June 22, 2021

**Major Site Plan Application**  
**S&N Investments LLC**  
**Proposed Tier 3 Marijuana Cultivation Facility**  
**24 Gambo Road**  
**Windham Assessor's Map 41, Lot 4**  
**Response to Comments**

### **Response to Staff Comments Received June 16 and 17, 2021**

Pond 1P: Grassed UDSF

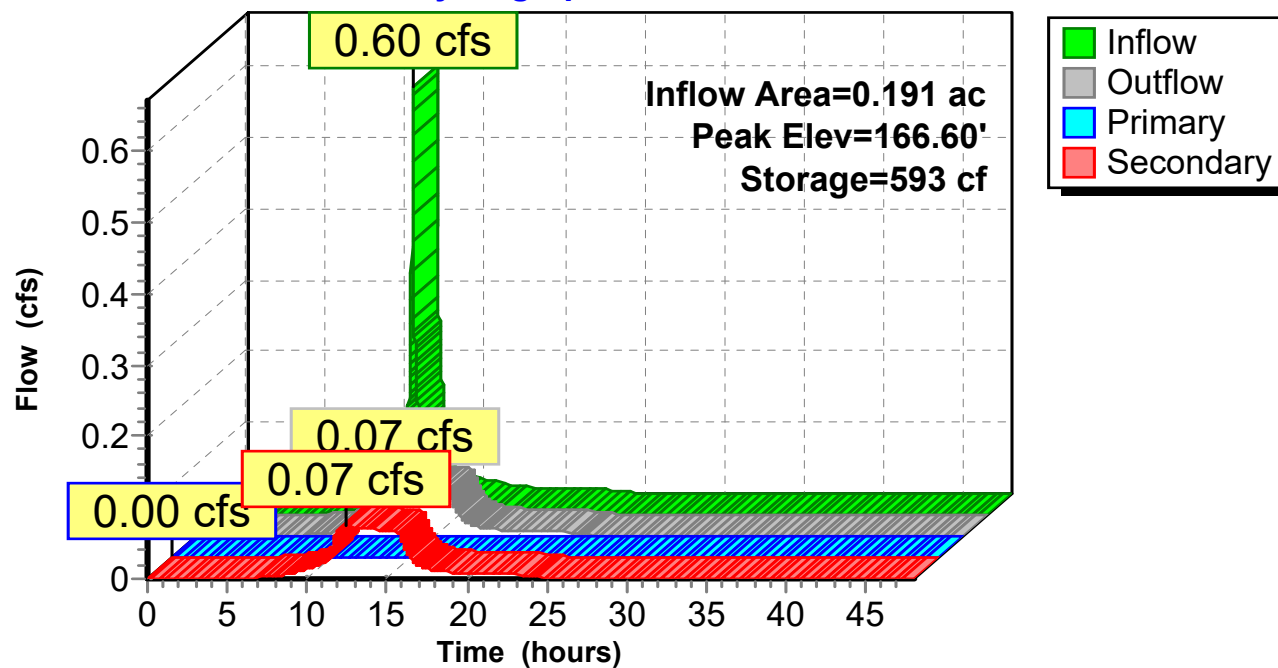
- *The Maine DEP requirements for a UDSF is that it must drain the stored volume in no less than 24 and no more than 48 hours. The stormwater modeling results provided in the application seem to indicate that the basin will drain in less than 24 hours. The Applicant should clarify.*

- Our office has reviewed and revised the Stormwater Model for the proposed Grassed UDSF to assess the timing for the basin to drain. In the prior model, the proposed underdrains were inadvertently overlooked in the modeling data. In addition, the phase-in depth for the exfiltration was corrected to reflect the base of the Grassed UDSF. Please note that the perforated underdrain size has been revised to 4" in the base of the BMP. Although these changes had no effect on the overall peak discharge rates previously calculated at Study Point 1 during each storm event, there were minor changes in the predicted water surface elevations in the Grassed UDSF and the time to drain the BMP equates to 24 hours.

In reviewing the table (non-shrunk) for the hydrograph results for the revised modeling, it shows that, in the 2 year storm event, the secondary flow from the filter ends at approximately 24 hours, which is within the MDEP's 24 to 48 hour timeline for pond drainage. We have enclosed a pdf print out of this hydrograph data.
